Ogg.: **"HD 900" FRIGGITRICI, SOSTITUZIONE LIMITATORI DI TEMPERATURA.**

Obj.: **"HD 900" FRYERS, SAFETY THERMOSTATS REPLACEMENT.**

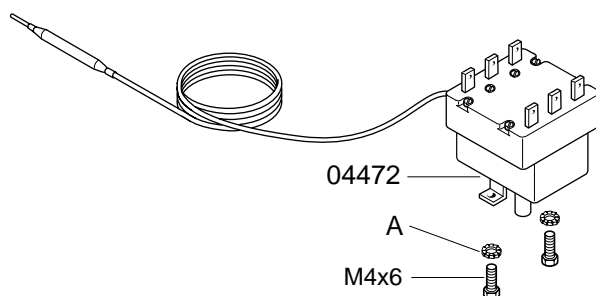
**FRIGGITRICI ELETTRICHE** - Da matricola 901....., il vecchio limitatore a codice 59559 è stato sostituito dal nuovo a codice 04472.

L'intercambiabilità è possibile, utilizzando due viti "M4x6" con rondelle dentate "A" come da figura e collegando elettricamente il limitatore, seguendo le indicazioni dei riferimenti da abbinare riportati nella tabella sottostante.

**ELECTRIC-HEATED FRYERS** - From serial number 901..... onwards, the old thermostat 59559 has been replaced by the new code 04472.

The new part is interchangeable with the old one by using two "M4x6" screws with toothed washers (see reference "A" in the picture here below) and connecting the electric wires as described in the table underneath.

Rif. cavo Ref. cable	Rif. limitatore Ref. thermostat
1	11
2	12
